**Technical Response to NRC's Rebuttal of My
Analysis of NIST ASR Findings for
Seabrook Safety**

Prof. Victor E. Saouma (*Emer.*)
University of Colorado, Boulder
C-10 Research and Education Foundation Consultant

The Advisory Committee on Reactor Safeguards. *Washington, DC*

August 31, 2025

Figure 1: Unanticipated pre-test delamination

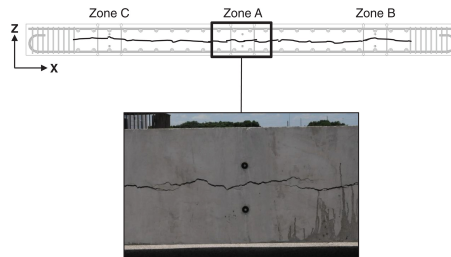
Turning to the LSTP tests, two distinct failures are evident:

Unintended: The absence of vertical reinforcement in the center of the beam allowed vertical expansion, producing a large delamination crack *before the test even started*. This flaw rendered all subsequent results highly questionable (Fig. 1).

Figure 2: LSTP specimen with shear and moment (flexure) diagrams

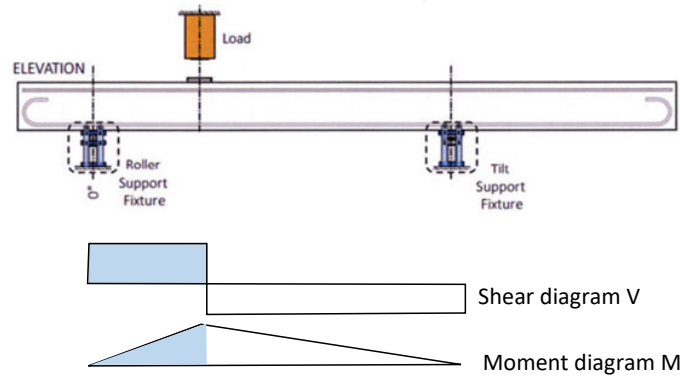
Intended: Since the purpose of the LSTP was to investigate the impact of AAR on shear strength degradation, the specimen should have been designed to maximize shear and minimize flexure. The NRC itself recognizes this necessity (see slide 4). However, even setting aside the pre-test delamination, the governing mode was not pure shear but rather *flexure-shear*². In the critical zone, significant shear was accompanied by a non-negligible moment—precisely the situation for shear walls with larger aspect ratios that the NRC criticizes in the NIST tests (Fig. 2).

Figure 3: LSTP vs. in-plane shear tests by others

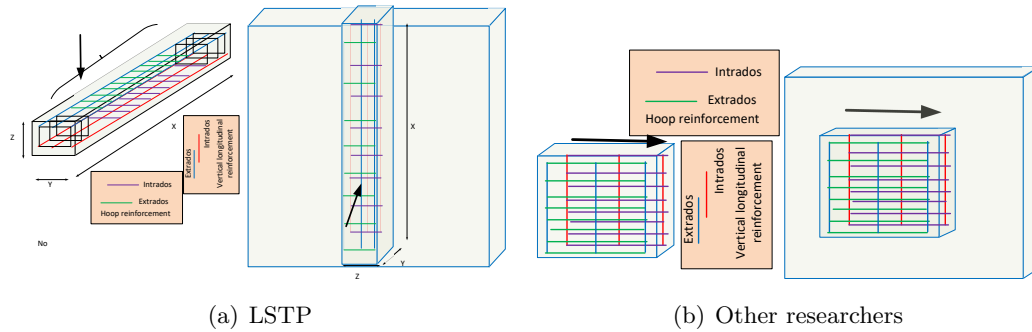
I agree that the configuration is indeed **unconventional** and **unrepresentative** of the shear resisted in a cylindrical containment subjected to lateral load. It is universally accepted that in this case, the lateral load is resisted by *membrane in-plane* shear,⁶ not by out-of-plane shear.

- The LSTP setup is illustrated in Fig. 3(a). Note that pre-test delamination occurred in the center segment of the specimen. What is actually modeled is a narrow vertical strip

of the wall by “punching” through it. This strip is artificially **laterally constrained** by adjacent concrete; such edge effects could have been reduced had the LSTP tested a plate rather than a beam. Key differences are:

- **Dimensionality:** Beam theory is 1-D; plates are 2-D with coupled curvatures (κ_x, κ_y) and twisting M_{xy} . Beam tests cannot capture M_y or M_{xy} .
- **Shear field:** Beams develop primarily Q_x (τ_{xz}), whereas plates carry bidirectional shear Q_x, Q_y (τ_{xz}, τ_{yz}). Beam tests miss through-width shear flow.
- **Crack mechanics:** Beams transition flexure \rightarrow flexure-shear. Plates develop **two-way crack fields** (diagonal + transverse) governed by biaxial bending and in-plane shear.
- **Torsion/biaxial coupling:** Plates experience twisting moments and Poisson coupling; beams omit these effects.
- **Size (width) effects:** Plate response reflects finite-width phenomena (shear-lag, stress redistribution). Beams lack a mechanism to capture this.

Thus, while I strongly disagree with the design philosophy of relying on out-of-plane shear, the handicap would have been at least partially mitigated had a plate been tested instead of a beam.

- By contrast, an **in-plane shear test** configuration, Fig. 3(b), would be far more representative of the structural response of an NPP containment under lateral seismic load. By limiting the height, flexural effects are minimized and shear clearly dominates.

Bottom line: to the best of my knowledge, the LSTP is the **only test program in the world** that relies on **out-of-plane shear** (Fig. 3(a)), in stark contrast to other researchers who correctly test **in-plane shear**.

Figure 4: Effect of underestimation of E_0 in expansion prediction

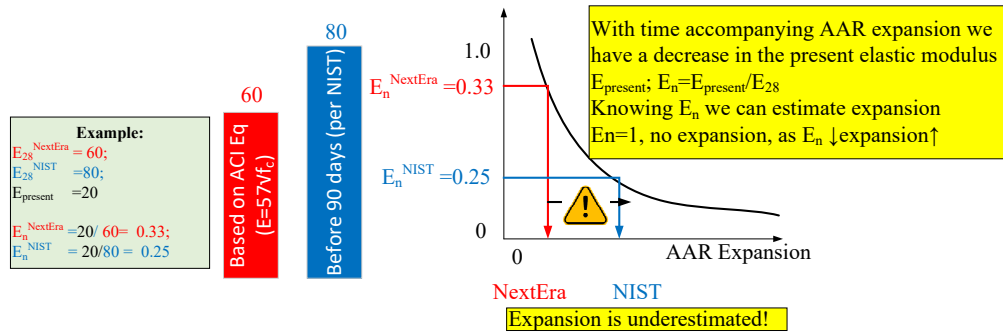
In instances where the empirical modulus equation over-predicts the original elastic modulus, use of the modulus-expansion correlation adds conservatism to the approach. In instances where the empirical equation under-predicts the original modulus, application of the normalized-modulus reduction factor adds sufficient conservatism to account for variability. (Publicly Available Report MPR-4153 (ML16279A050), p4-4)

- **The NRC's first claim is categorically wrong.** The NRC states: “*In instances where the empirical modulus equation over-predicts the original elastic modulus, use of the modulus-expansion correlation adds conservatism to the approach.*” This is the exact opposite of reality⁹. As clearly shown in Figure 4, when the initial modulus is over-predicted ($E_0 \nearrow$), the normalized modulus decreases ($E_n \searrow$), which leads to **increased predicted expansion** ($\epsilon^{AAR} \nearrow$). This is **non-conservative**, not conservative.

- **The NRC's second claim is equally flawed.** They state: “*In instances where the empirical equation under-predicts the original modulus, application of the normalized-modulus reduction factor adds sufficient conservatism to account for variability.*” Again, the physics is backwards: when E_0 is under-predicted ($E_0 \searrow$), the normalized modulus increases ($E_n \nearrow$), leading to **decreased predicted expansion** ($\epsilon^{AAR} \searrow$). The system naturally becomes more conservative in this case, **without any reduction factor**.

- **The NRC made a blatant error in analyzing the impact of elastic modulus under-prediction.** Their claim that over-predicting the original elastic modulus “adds conservatism” is physically incorrect—it actually leads to non-conservative (higher) expansion estimates, as demonstrated in Figure 4.
